**RE: ADDRESS OF VISUAL IMPACT MATTERS, MARIST CATHOLIC COLLEGE NORTH SHORE**

Thank you for asking Ethos Urban to address the Response to Submissions document (RtS) issued by the Department of Planning, Industry and Environment (DPIE) in relation to visual impact matters for alterations and additions to the Marist Catholic College North Shore proposed under SSD-10473.

This response constitutes an update to the Visual Impact Assessment (VIA) previously prepared by Ethos Urban and dated 17 December 2020 in the form of an addendum. In this regard, it is to be read on conjunction with this earlier document. It also should be considered together with the updated Heritage Impact Statement prepared by Weir Phillips Heritage and Planning.

**Figure 1: Proposed site plan**

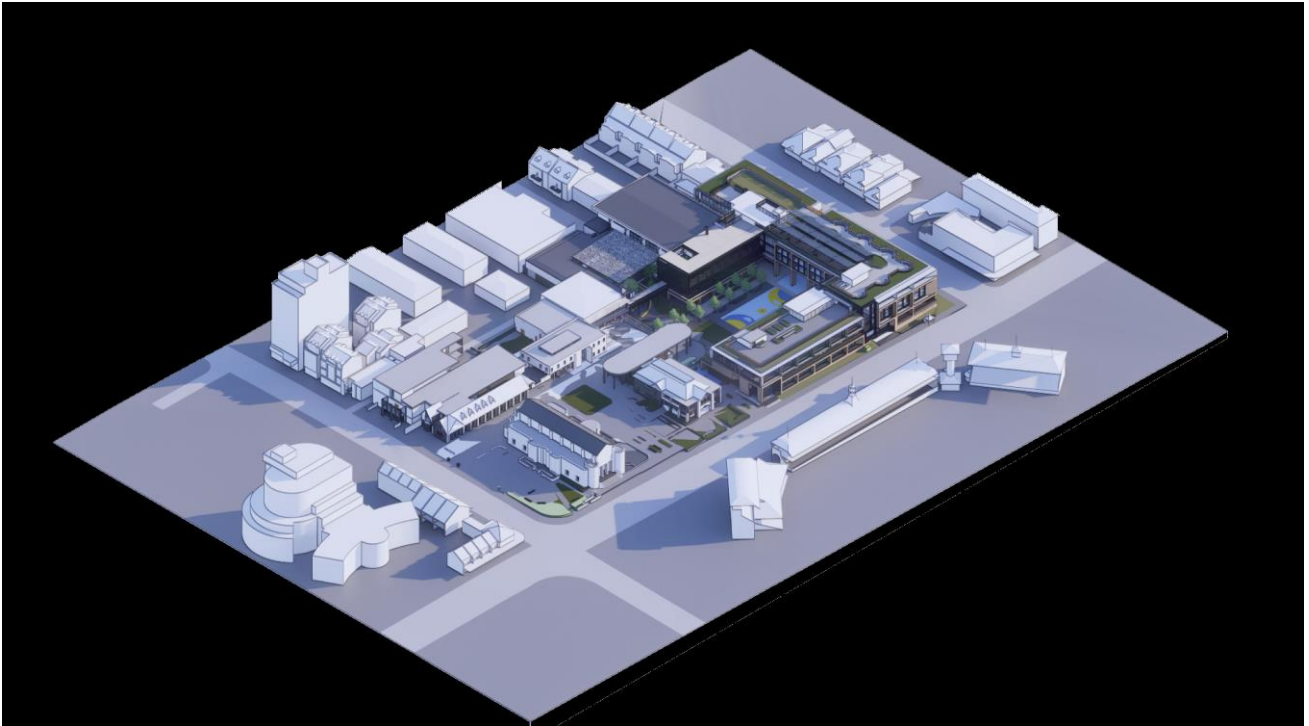
- The Visual Impact Assessment (VIA) report is to be updated to consider the visual impacts that would eventuate from the proposed setbacks and the bulk and scale of the proposed buildings on the site's surrounding heritage items
- Further consideration should be given to the potential to provide natural screening for the site in order to reduce the bulk and scale of the proposed building. This may require consideration of street tree planting, if there is not sufficient space within the site
- Consideration to further articulate the façade on Miller Street and stepping the building down following the slope of the land should also be considered.

In response to this RtS, Sydney Catholic School has made a number of amendments to the proposal. The main amendment is removal of the upper level of the Miller Street building. The amended proposed is shown in **Figure 1** and **Figure 2**.

As can be seen in **Figure 1** and **Figure 2** the proposal rearranges this footprint to create a L shape. As a consequence, that part of the Miller Street building facing the Presbytery now only extends for approximately half its length. This is considered to allow for an improved visual appreciation of the Presbytery.

**Figure 3: Adjoining, adjacent and nearby heritage items**

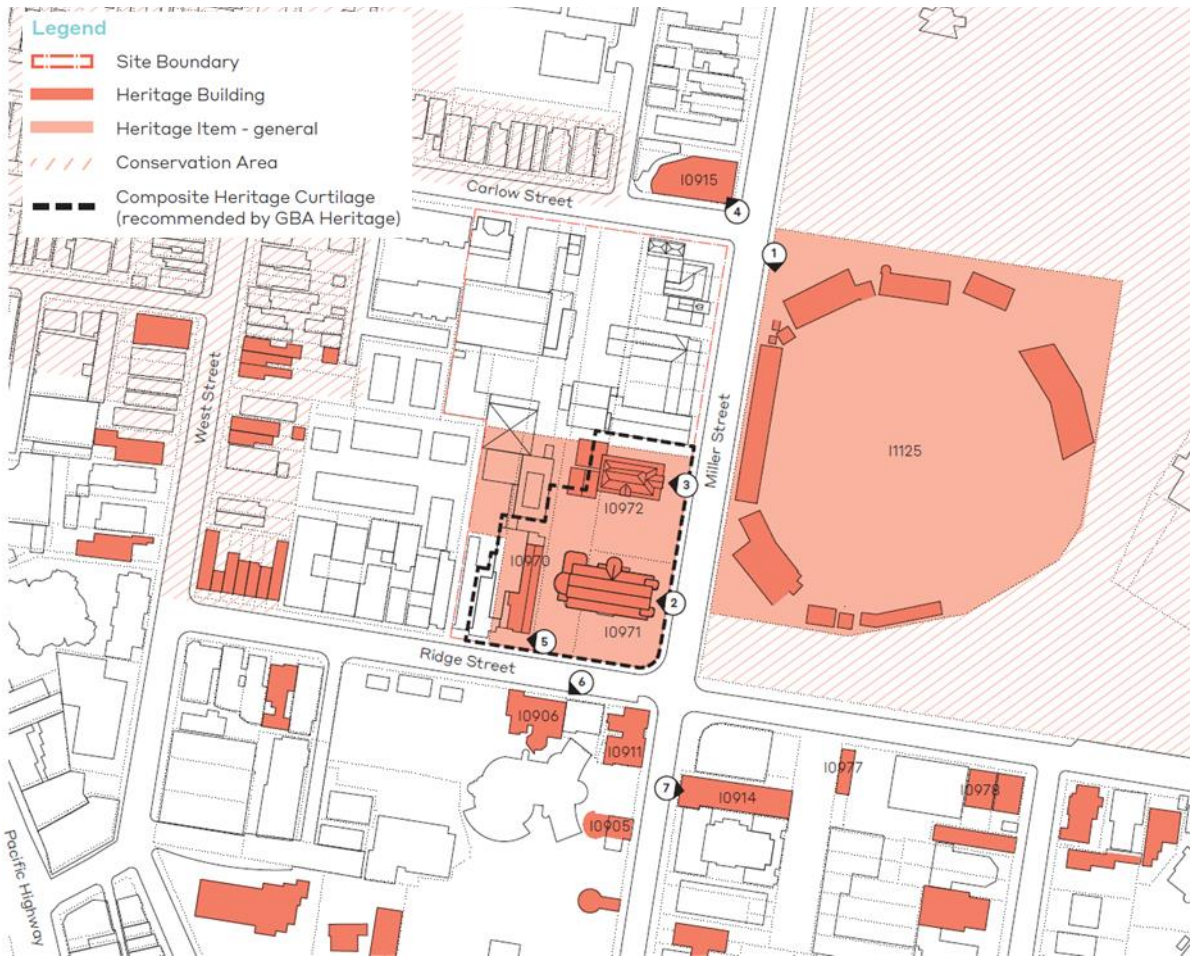
The Visual Impact Assessment (VIA) report is to be updated to consider the visual impacts that would eventuate from the proposed setbacks and the bulk and scale of the proposed buildings on the site's surrounding heritage items

As is shown in **Figure 3**, the proposal is located close to the following local heritage items listed under the North Sydney Local Environmental Plan 2013 (NSLEP2013):

- adjacent to the St Mary's Catholic Presbytery
- opposite Carlow Street from the North Sydney Hotel
- opposite Miller Street to the North Sydney Oval.

**Figure 5: Originally proposed Miller Street extended streetscape elevation - south**

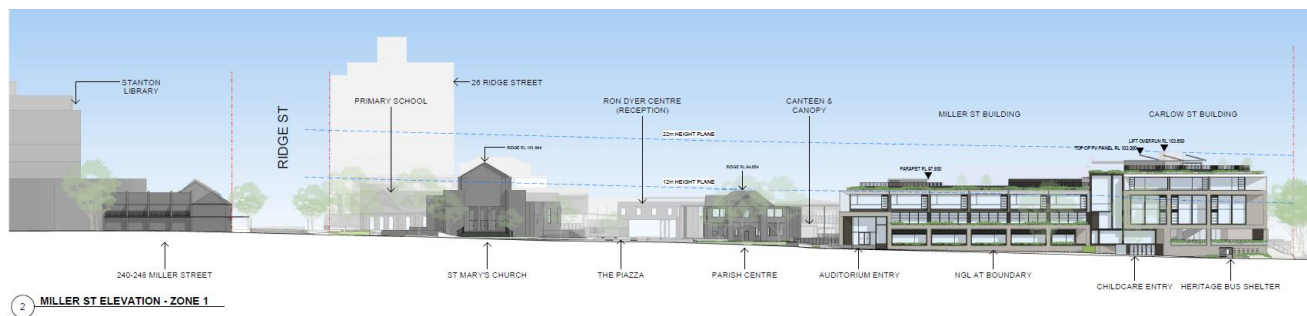
The footprint of the existing building on this part has a U shape. As a consequence, the three storey (3) southern building has its long elevation adjoining the entire length of the Presbytery.

In addition, Sydney Catholic Schools is proposing to remove the entire third storey of the Miller Street building. As can be seen in **Figure 5** and **Figure 6**, the reduced height is consistent with that of the Presbytery. In addition, the proposal also responds to the Presbytery's parapet and ridge height. The additional height of the Miller Street building is rec

While the proposal will not be seen in views from the adjoining public domain together with the entirety of the religious complex, **Figure 6** nonetheless shows its relationship with the western side of the Miller Street streetscape between Carlow Street and Ridge Street. As can be seen, the maximum height of the proposal, which is reached at its northern end by the Carlow Street building, is consistent with that of St Mary's Church being the visually dominant element in the religious complex in Maximum height of the structure.

**Figure 7: Visualisation of proposed Miller Street and Carlow Street intersection**

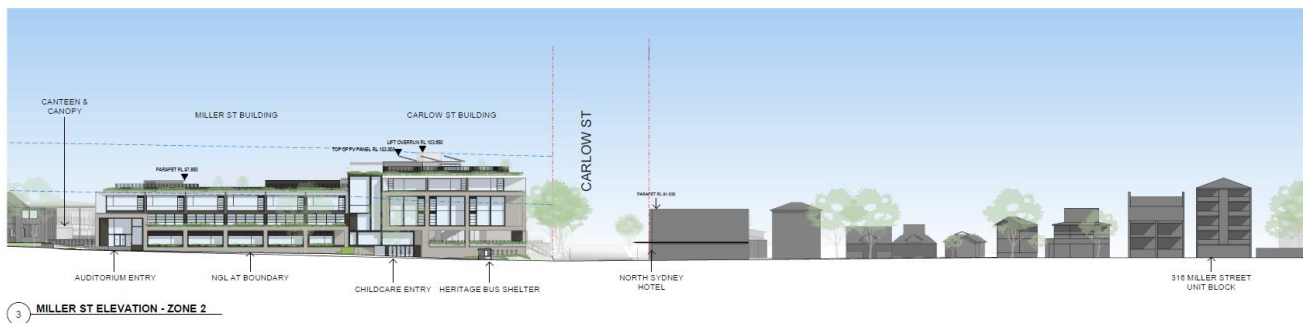
As can be seen in **Figure 2**, the proposals massing is greatest at the site's north-east corner adjacent to the North Sydney Hotel. When seen from Miller Street, this creates a streetscape pattern that accentuates the two western corners of the intersection of Miller Street and Carlow Street.

While of greater height and bulk to the North Sydney Hotel, as is shown in **Figure 7** and **Figure 8**, this is not considered to constitute a visually unacceptable relationship. The height difference will be read as approximately 1.5 storeys. As shown in **Figure 8**, it is noted that a similar height already exists in the Miller Street streetscape nearby and to the north of the site. The length of the Carlow Street building to Miller Street is also not considered to be visually excessive when read together with the North Sydney Hotel.

The street facing elevations of the proposal have been heavily broken up into smaller elements, and features considerable glazing and other details that further reduce the appearance of building scale and bulk.

**Figure 9: Proposed Carlow Street extended streetscape elevation**

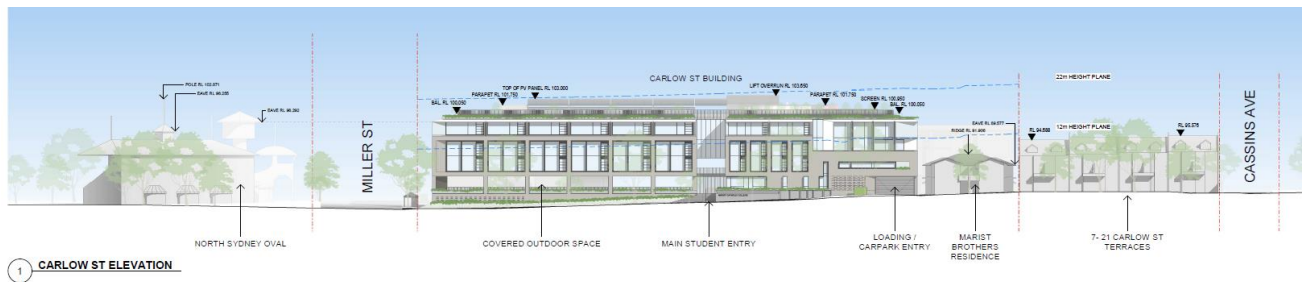
## Scale and bulk

The Carlow Street building is of greater height to the North Sydney Oval. However, as is shown in **Figure 9**, the height difference will be read as one storey. This storey will be largely glazed, featuring large, long horizontally oriented windows and capped by roof top vegetation. This will have the effect of reducing the appearance of height. It is also important to note that the full length of the Carlow Street building will not be seen in most views in which the North Sydney Oval is visible.

**Figure 12: Trees proposed to be retained and removed**

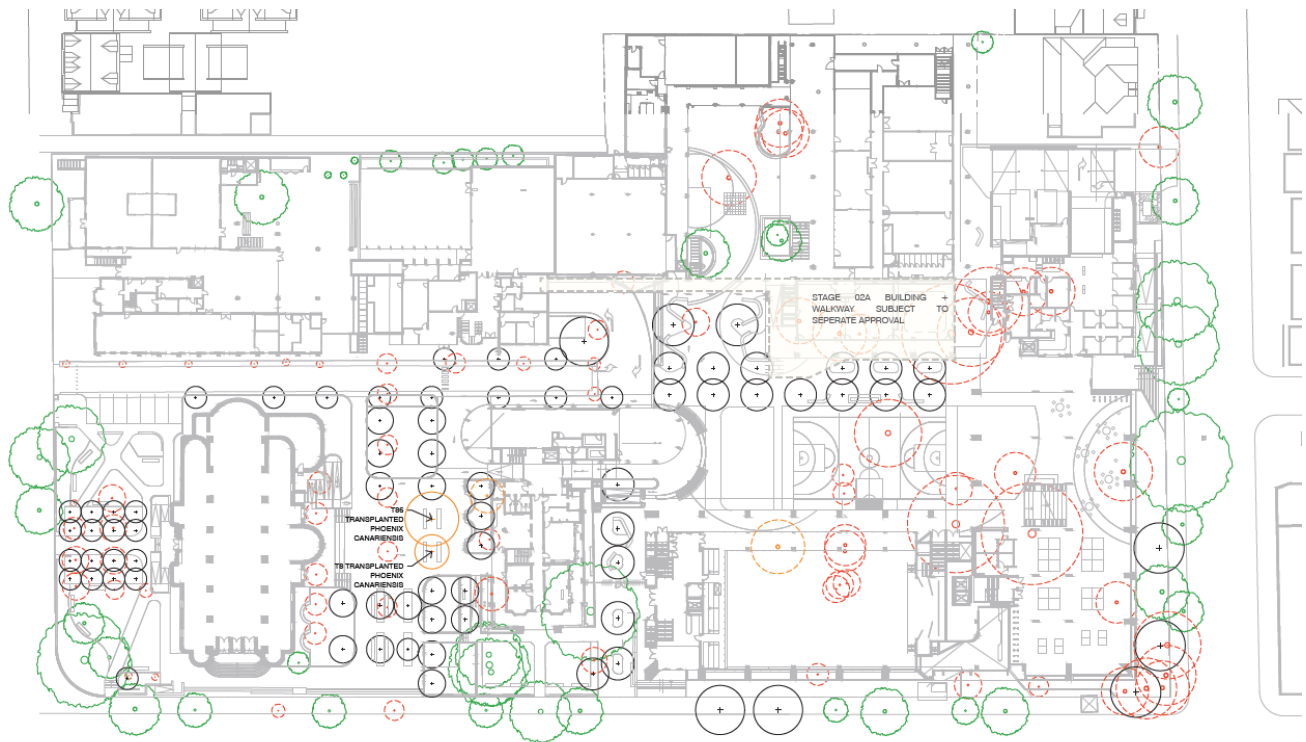
- Further consideration should be given to the potential to provide natural screening for the site in order to reduce the bulk and scale of the proposed building. This may require consideration of street tree planting, if there is not sufficient space within the site

As can be seen in **Figure 12**, most existing and larger street trees in Miller Street and Carlow Street are proposed to be retained. The mix of trees within the site that are compromise the built form massing strategy are proposed to be removed.
